G0.10 --- CODE ANALYSISREVISED SUBMITTAL - PL20220623

G0.10 --- CODE ANALYSISORIGINAL SUBMITTAL - PL20220623

The Amble

The Amble Steamboat, CO

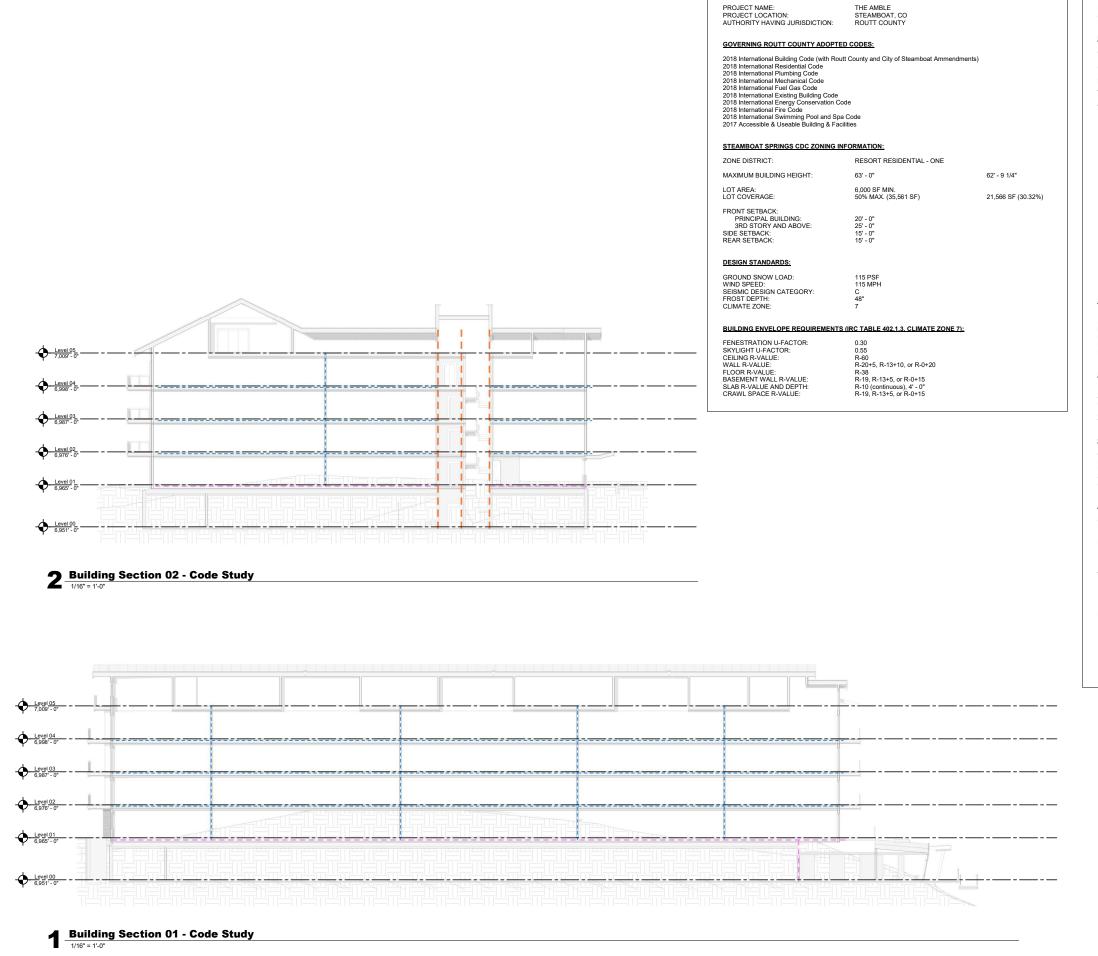
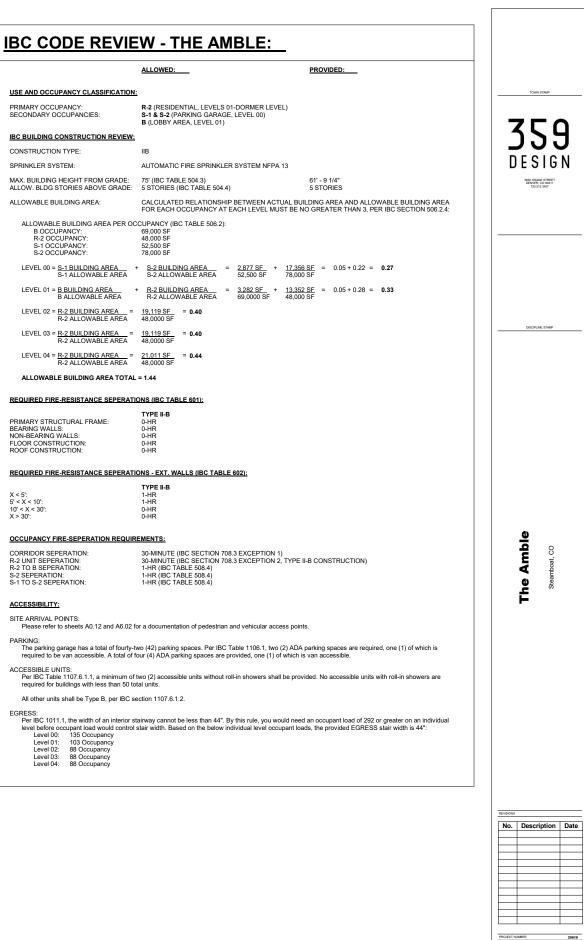
- 01. MAXIMUM BUILDING HEIGHT CHANGED FROM 62' 9 1/4" TO 62' 1 1/2" (RE: A7.02 FOR MORE INFORMATION)

02. LOT COVERAGE CHANGED FROM 21,566 SF / 30.32% TO 22,128 SF / 31.11% (RE: A0.02 FOR MORE INFORMATION)
- 03. MINOR UPDATES TO IBC CODE REVIEW TABLES TO MATCH BUILDING UPDATES

G0.11-60.13 --- ALS PLANS

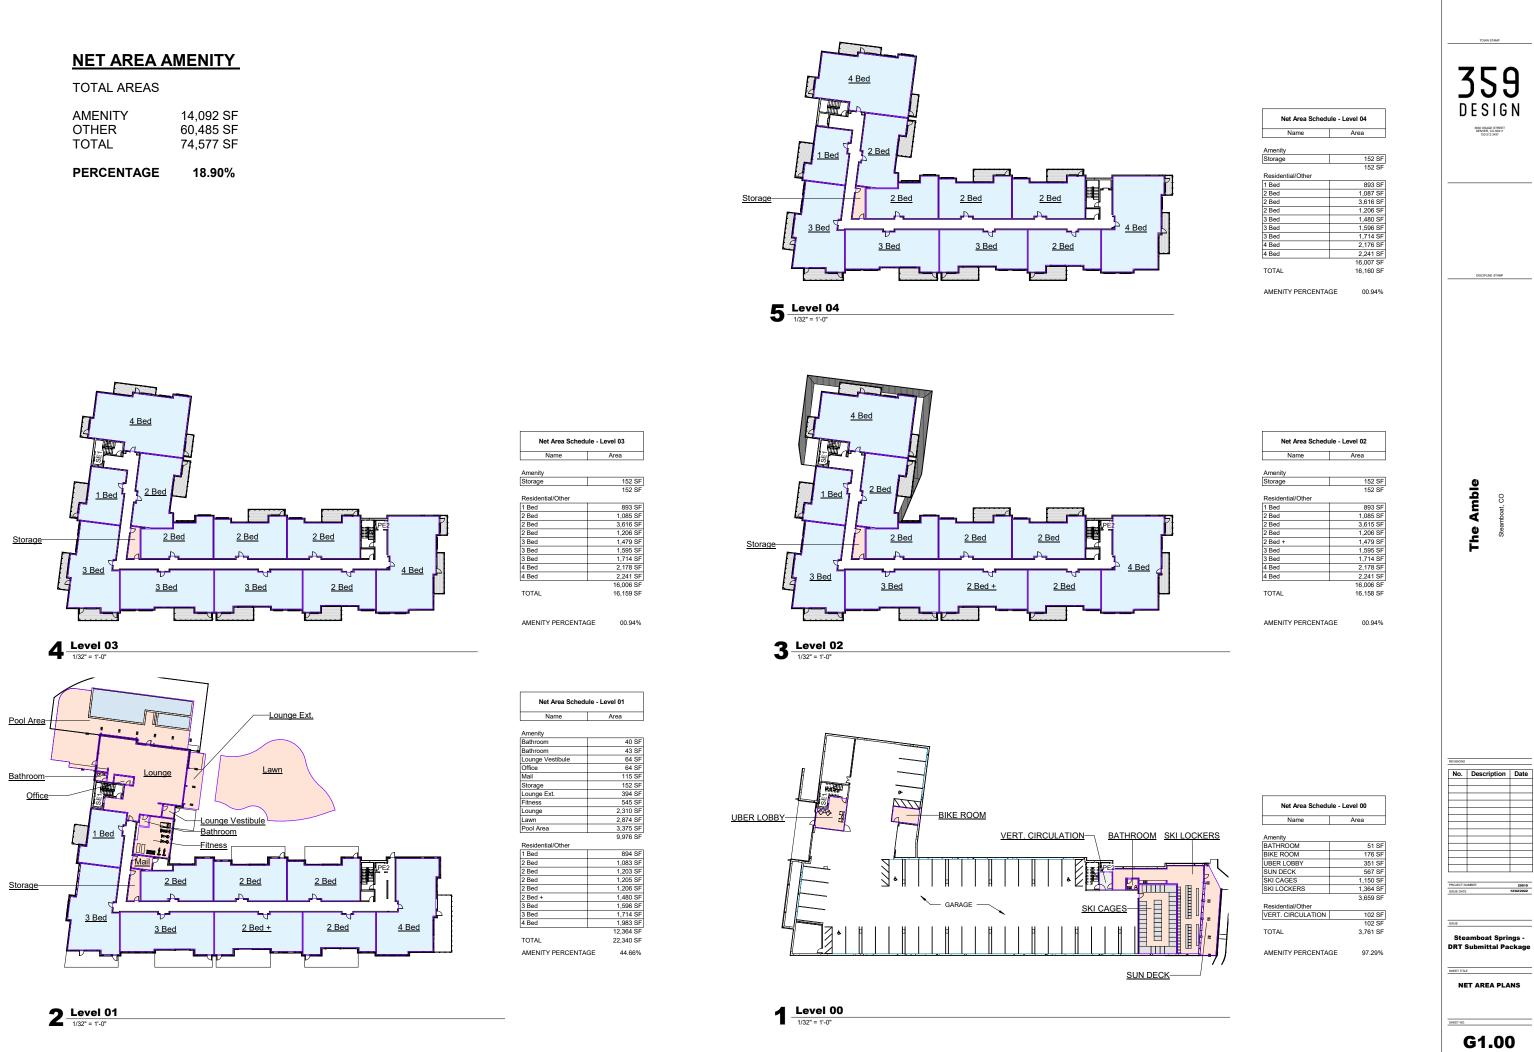
- 01. MINOR ADJUSTMENTS TO PROGRAM LAYOUT AT LEVEL 00 GARAGE (PREVIOUSLY LABELLED AS LEVEL 01). 02. MINOR ADJUSTMENTS TO LOBBY/GYM AND INTERIOR RESIDENTIAL CORNER AT LEVEL 01 (PREVIOUSLY
- LABELLED AS LEVEL 02).
- 03. ADDED DORMER LEVELS TO FIVE UNITS WHERE VAULTED SPACE WAS PREVIOUSLY SHOWN. SIMILAR TO UNITS WITH DORMER LEVELS PREVIOUSLY SHOWN, CIRCULATION TO THE DORMER LEVEL IS INTERIOR TO THE UNITS. NOTE: THE DORMER LEVEL WAS PREVIOUSLY REFERRED TO AS LEVEL 06, BUT IS NOW REFERRED TO AS LEVEL 06 THROUGHOUT THE SUBMITTAL SET.

G0.30 --- NET AREA PLANS REVISED SUBMITTAL - PL20220623

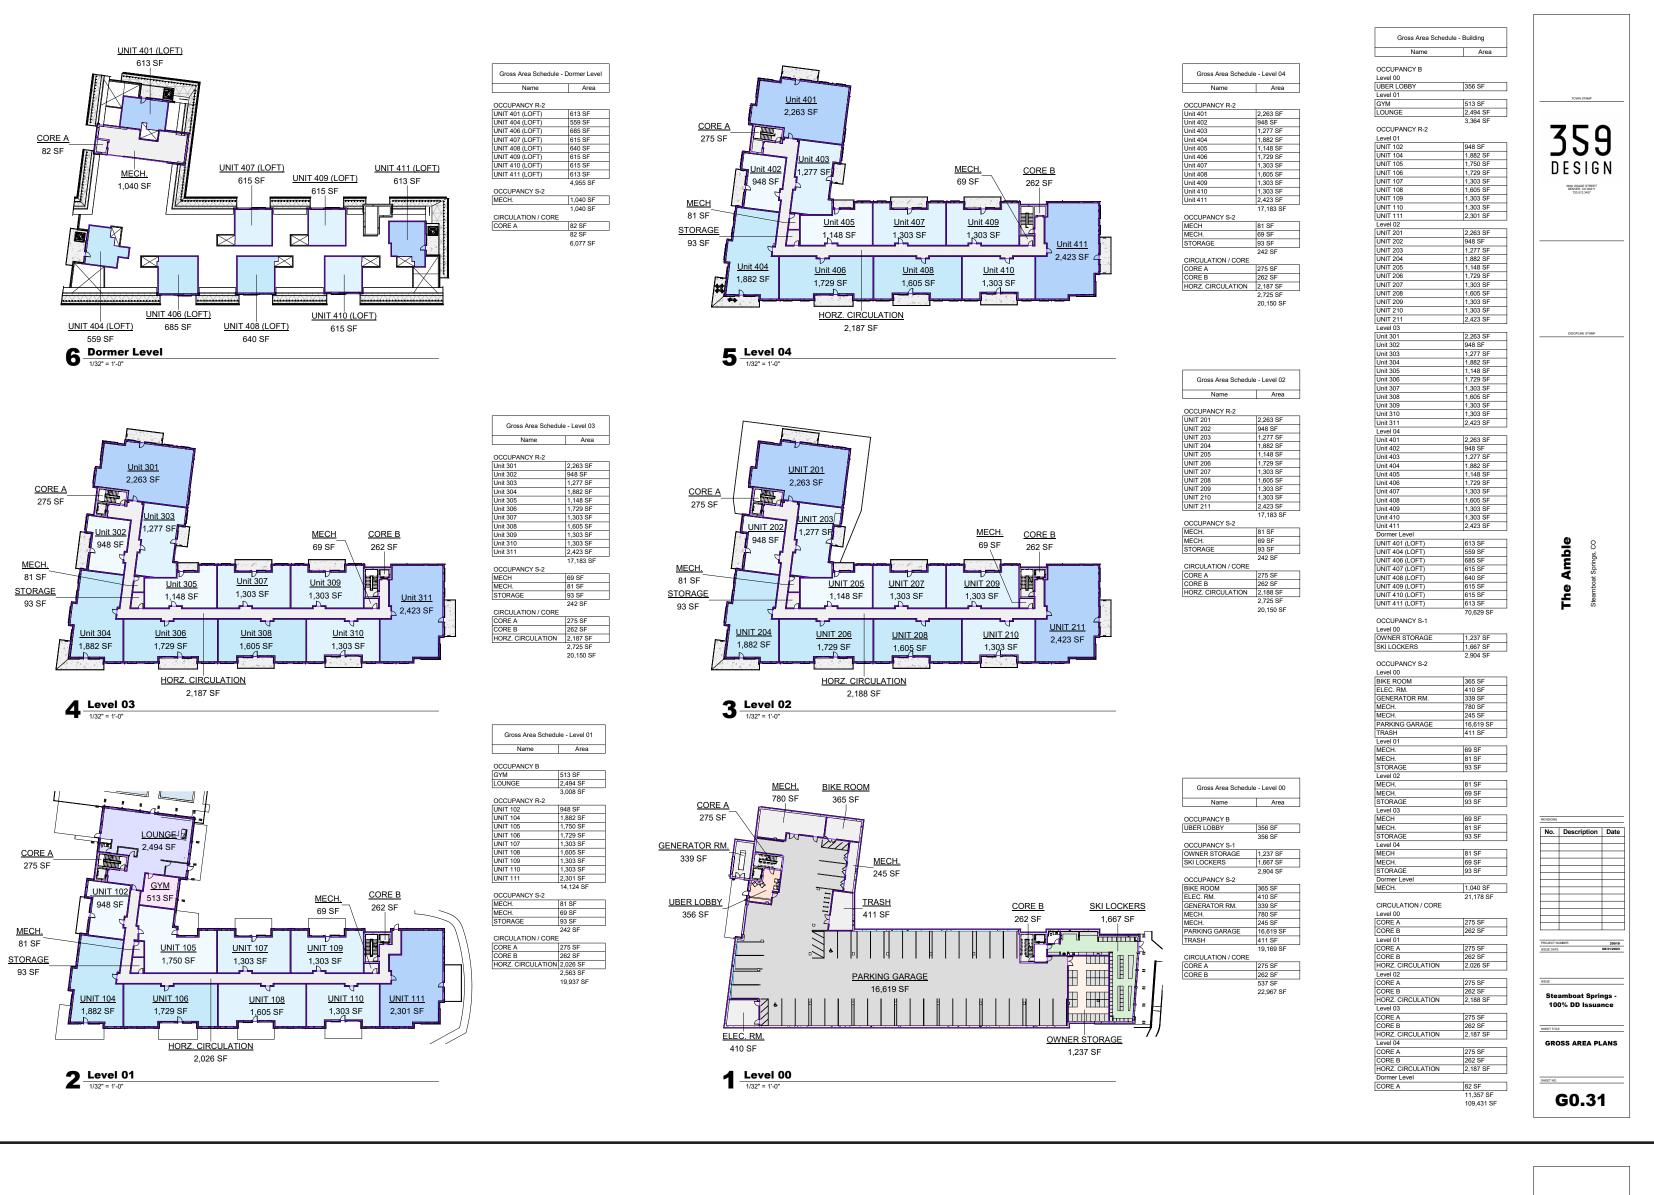
- 01. SHEET NUMBER UPDATED FROM G1.00 TO G0.30.
- 02. TOTAL NET AREA UPDATED FROM 74,557 SF TO 80,990 SF.

03. TOTAL AMENITY NET AREA UPDATED FROM 14,092 SF (18.90%) TO 14,009 SF (17.30%). A MINIMUM OF 15% NET AMENITY SQUARE FOOTAGE IS REQUIRED.

G0.31 --- GROSS AREA PLANS REVISED SUBMITTAL - PL20220623

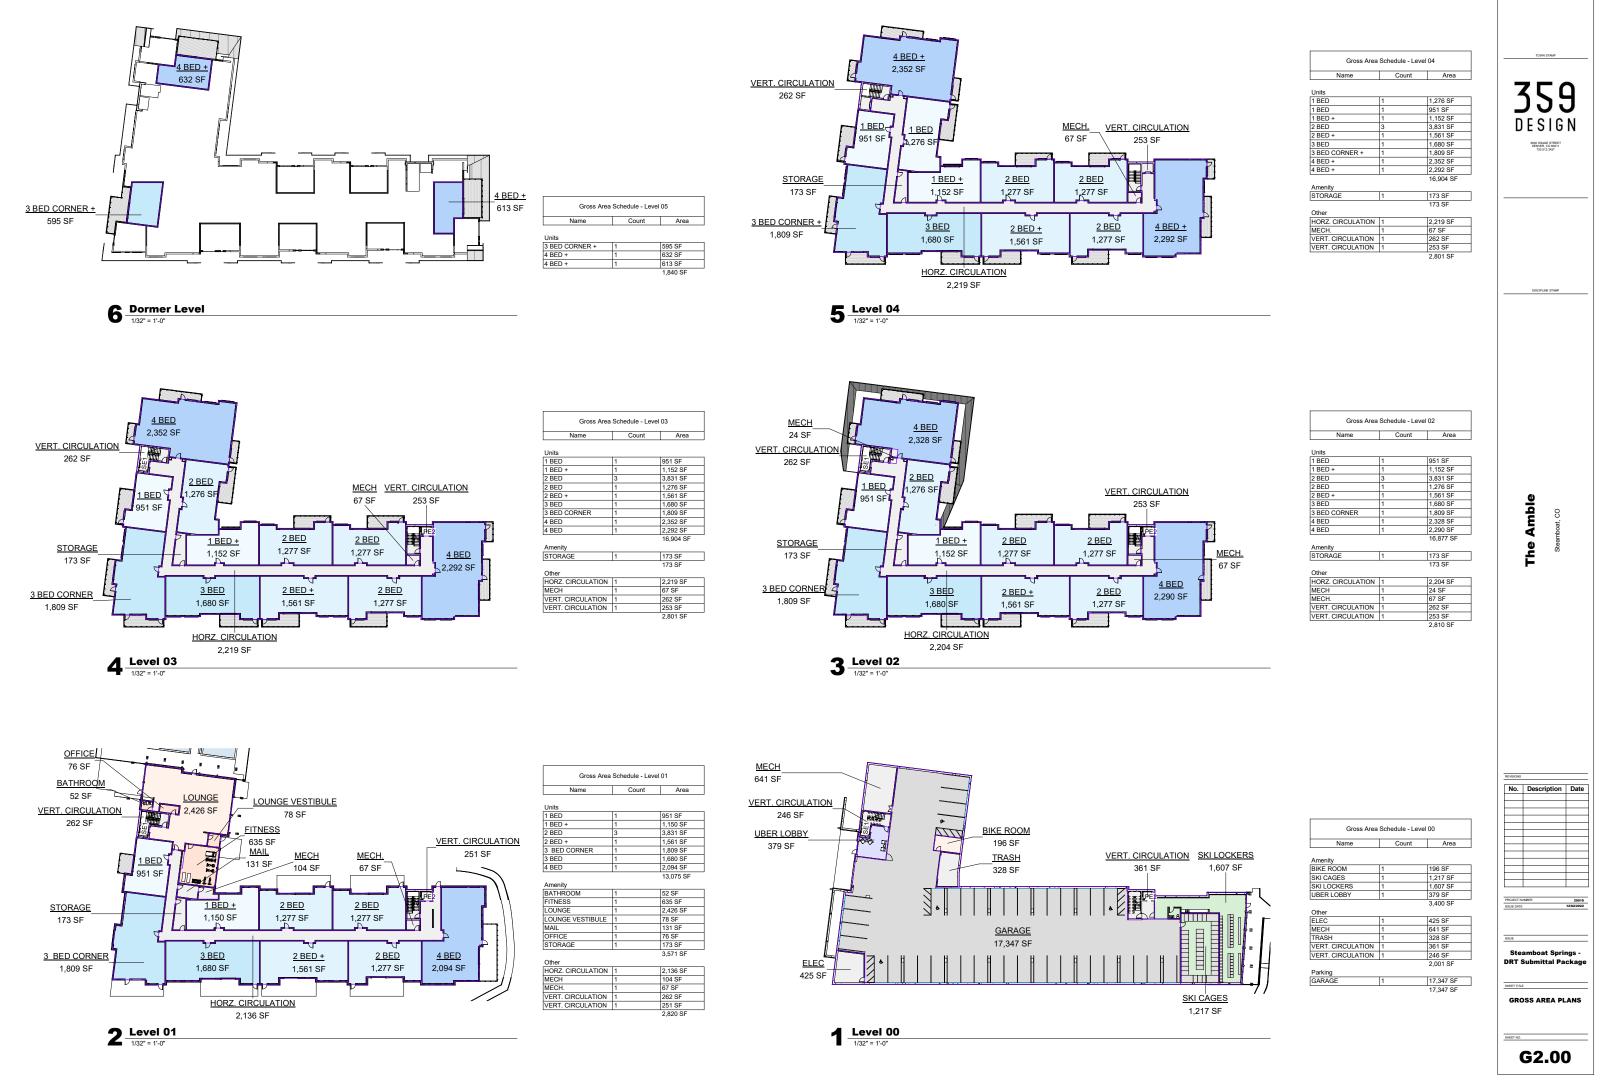
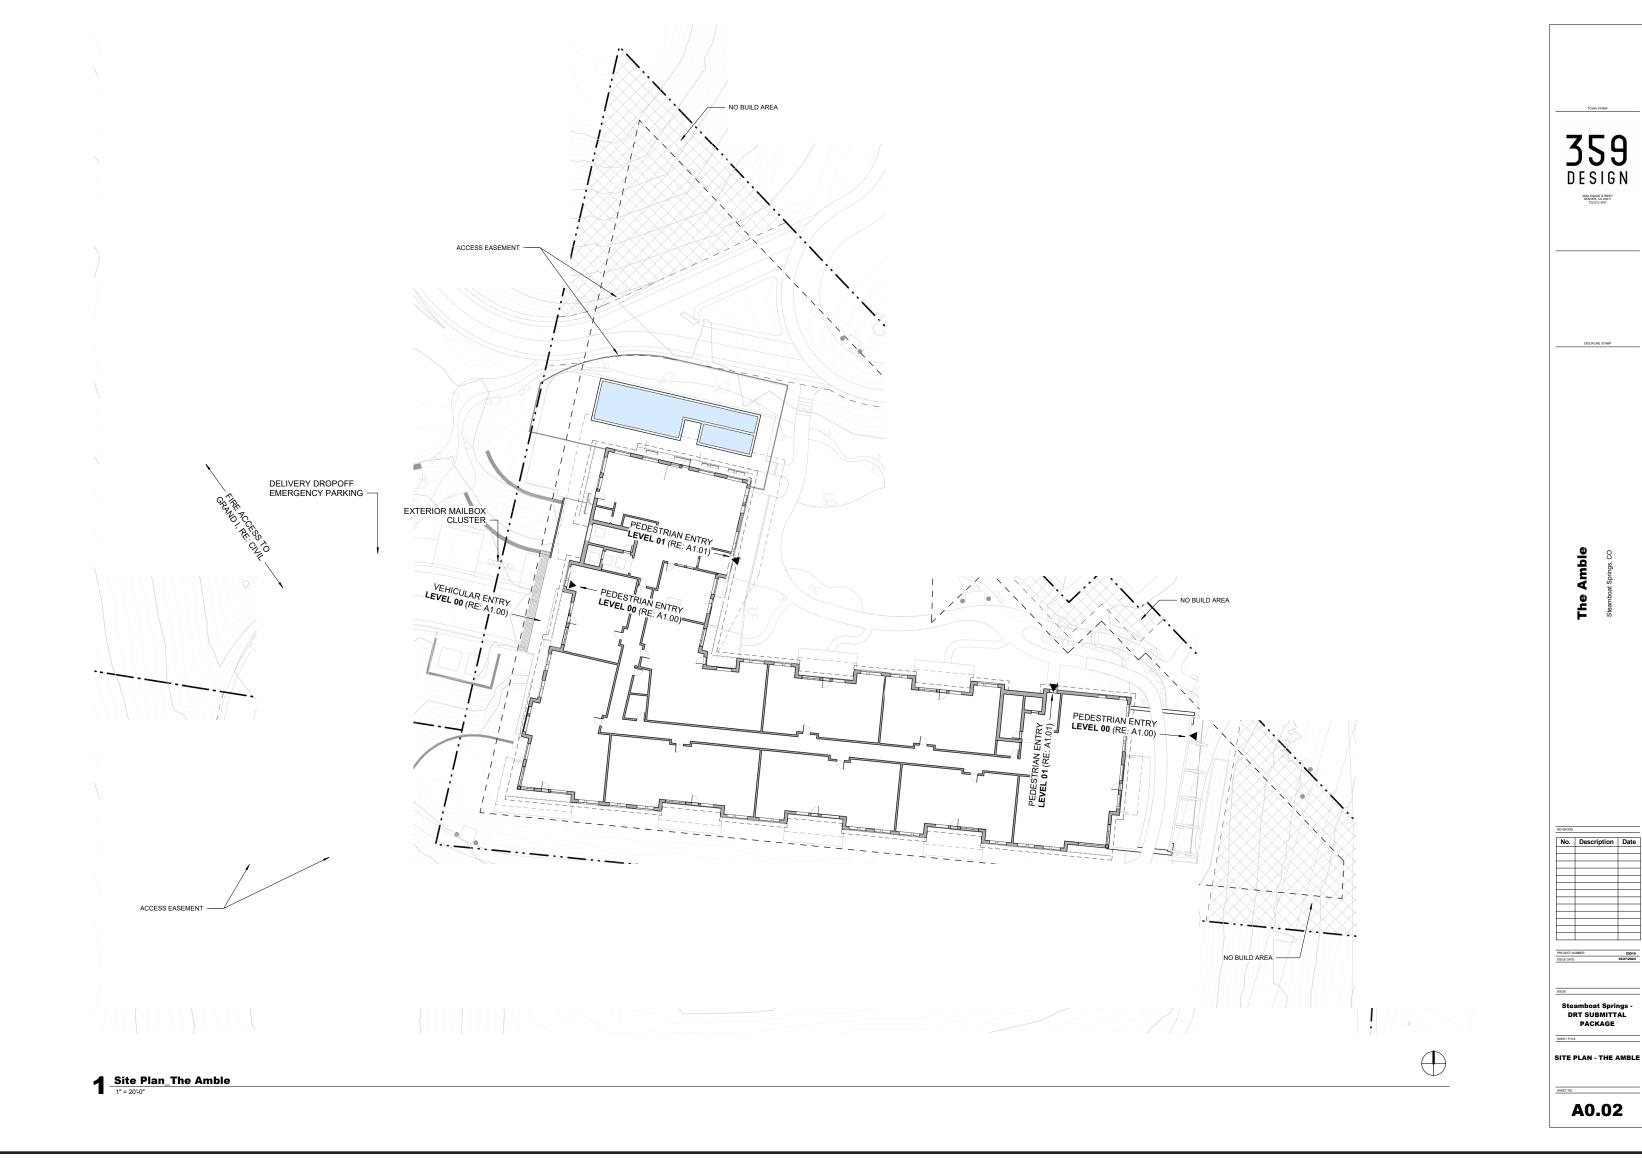
- 01. SHEET NUMBER UPDATED FROM G2.00 TO G0.31.
- 02. TOTAL GROSS AREA UPDATED FROM 103,688 SF (TOTAL NOT PREVIOUSLY PROVIDED ON G2.00) TO 109,431 SF. THE INCREASE IN GROSS SQUARE FOOTAGE IS LARGELY RELATED TO THE CHANGES NOTED ON PAGE 02 OF THIS PACKAGE.
